October 3, 2019

Mr. Dean K. Moos  
 Director, Reclamation & AML Divisions  
 Public Service Commission  
 600 E Boulevard, Dept. 408  
 Bismarck, ND 58505-0480

**Coyote Creek Mine 2015** *Surface Water Management related portions of inspections reports from 2015.*

Figure 1: SE1/4 of Section 24

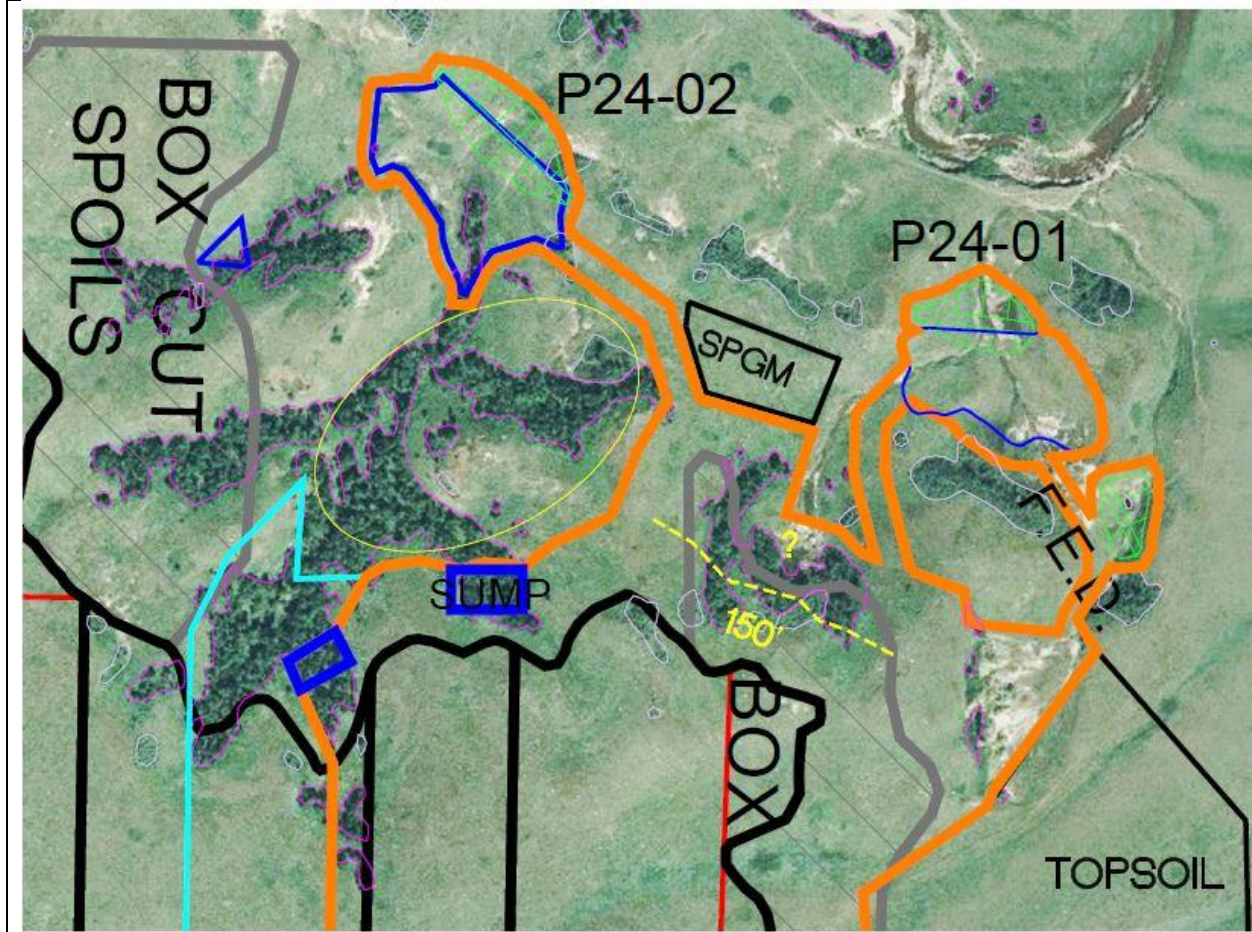
Two sumps are planned at the SPGM stripping boundary in wooded drainages above future sediment pond P24-02. The drainage above this pond is quite heavily wooded and the mineral removal boundary affects only the upper reaches of two drainages. The drainage way below the sump located furthest to the west was walked to the pool area of the pond. It was thought that most of this drainage way should not be stripped in an attempt to avoid the woodlands. The possibility of not stripping some of the steeper and narrow wooded drainages was discussed; however, the less steep drainages will require topsoil removal. A fraction of an acre of trees were shown in the pool area of sediment pond P24-02 and it was discussed that SPGM removal should only occur in the pool area of the pond to the permanent pool elevation level (PPE). This may result in avoiding disturbance to these trees. It was discussed that perhaps the eastern sump located above pond P24-02 would be unnecessary if a diversion along the SPGM removal area to the north could be cut to allow runoff to reach pond P24-02. A topographic map was not available on site to allow one to determine if a diversion along the SPGM stripping line was feasible. The watershed above the eastern sump comprises only a few acres while the watershed above the western sump is larger but only a few acres of SPGM are planned for removal in 2015.

The woodlands within the SPGM removal area located east of the eastern-most sump in the pond P24-01 watershed area are located on a very steep north facing slope that is slumping from ground water seepage. This area has the yellow 150' label on Figure 1. The woodlands associated with this very steep slope

The woodlands located immediately above sediment pond P24-01 are shown outside of the SPGM removal boundary and runoff will be routed around this area.

It appeared that perhaps an acre or less of woodlands would be disturbed in the SE1/4 of Section 24 if appropriate measures are taken to avoid woodlands in this area in 2015. Numerous photographs were taken and are on file with the Reclamation Division.

**Figure 3:** NW1/4 of Section 31.

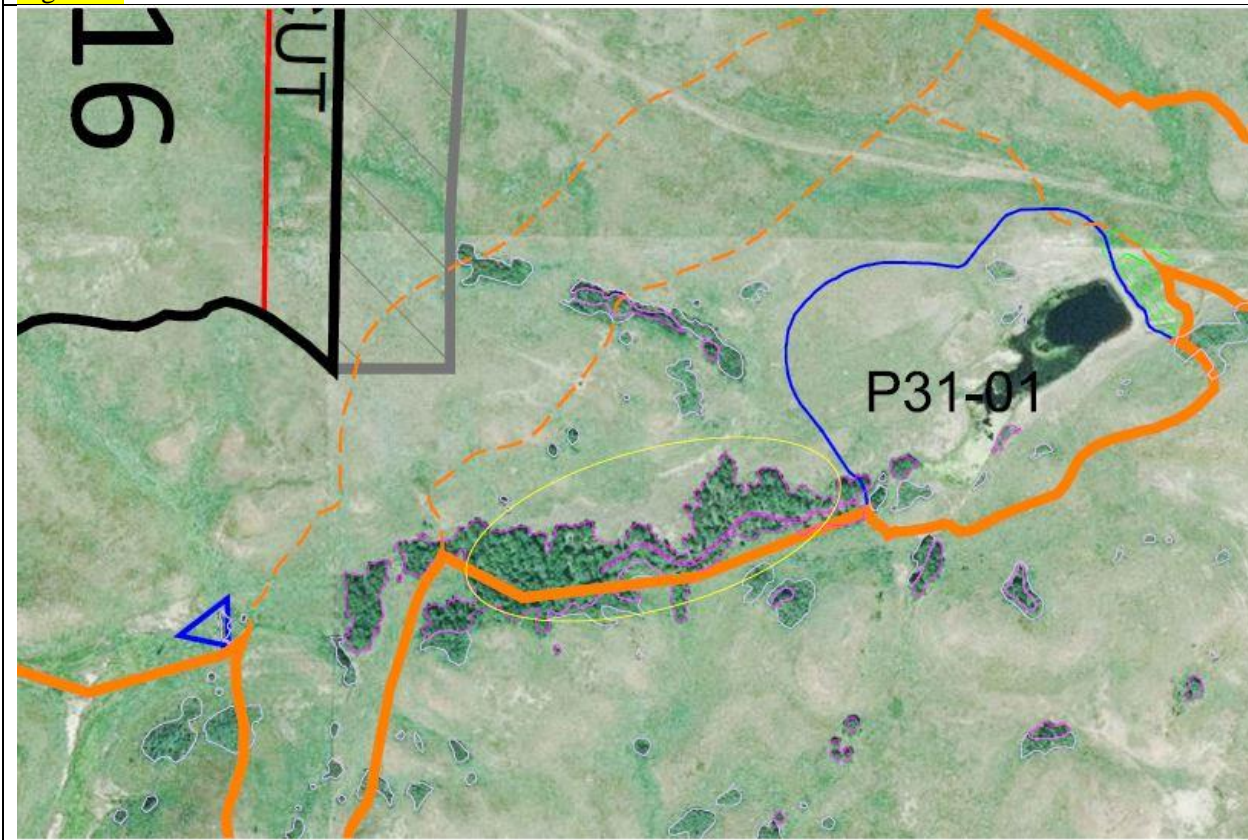
Woodlands associated with the drainage above pond P31-01 were inspected. Very little woodland acreage will be disturbed for construction of the pond (a fraction of an acre), but the drainage above the pond is quite heavily wooded. Most of the woodlands above this pond are identified as an area that will be avoided but the west end of the drainage is to be affected by the haul road. Given the size of the watershed above this pond it was discussed that perhaps runoff should not be allowed to pass through the undisturbed wooded drainage way. It appeared that this could be accomplished by a ditch block and the construction of a diversion that could be located along the north side of the drainage. Figure 3 is the map that was provided for the review of this area.

**Figure 1**

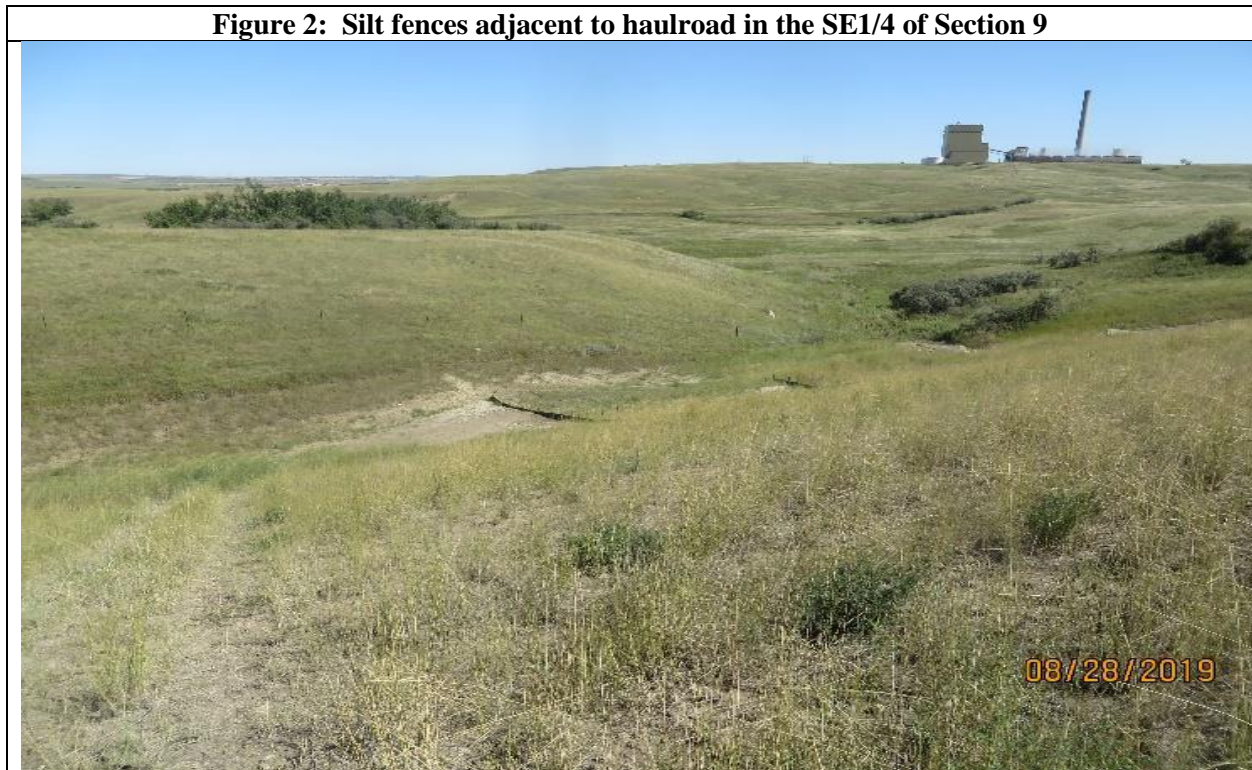
the two inspected sumps at the disturbance boundary need maintenance. Sediment has accumulated in these sumps and the silt fence of one sump is bent over from the force of water from a runoff event.

**Figure 1: Variance Areas 1 and 2 (outlined in Black), grade approvals (outlined in Red) and inspection route on 10/1/2019 (Blue)**

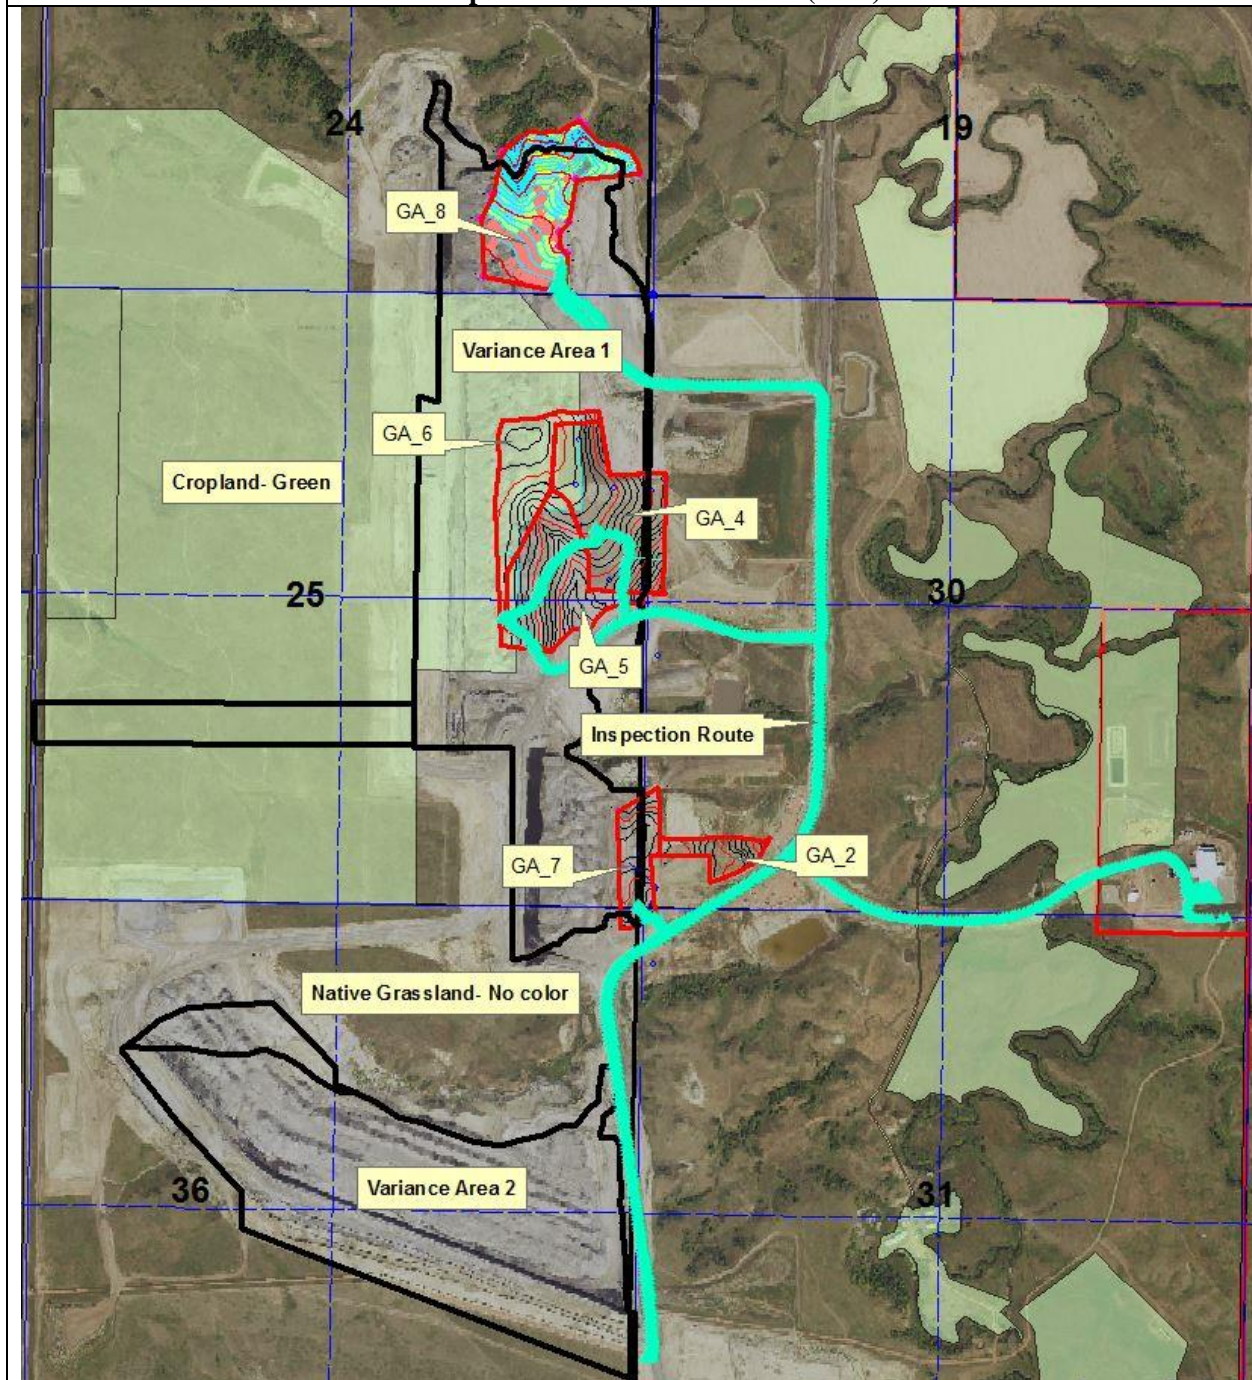
Grade approved areas that have been respread with subsoil and topsoil in the E1/2 of Section 25 and the SE1/4 of Section 24 were inspected. This included portions of grade approvals COY\_004, COY\_005, COY\_007 and COY\_008. Grade approval COY\_004 was respread with topsoil in 2018 and the other grade approvals were respread with topsoil in 2019. Rocks are generally picked after topsoil-respreading operations have been completed and the approved seed mixture or a temporary cover crop is then planted to protect the soil from erosion. Mulch may be applied and crimped into the soil surface if topsoil-respreading operations are completed outside of the growing season. The post-mining land uses within these grade approvals are cropland and native grassland. Narrative in Permit NACC-1302 allows CCMC to delay planting native grasslands for a year or more to control invasive non-native perennial grasses. Figure 1 below, depicts the grade approval areas and the route traveled during this inspection.
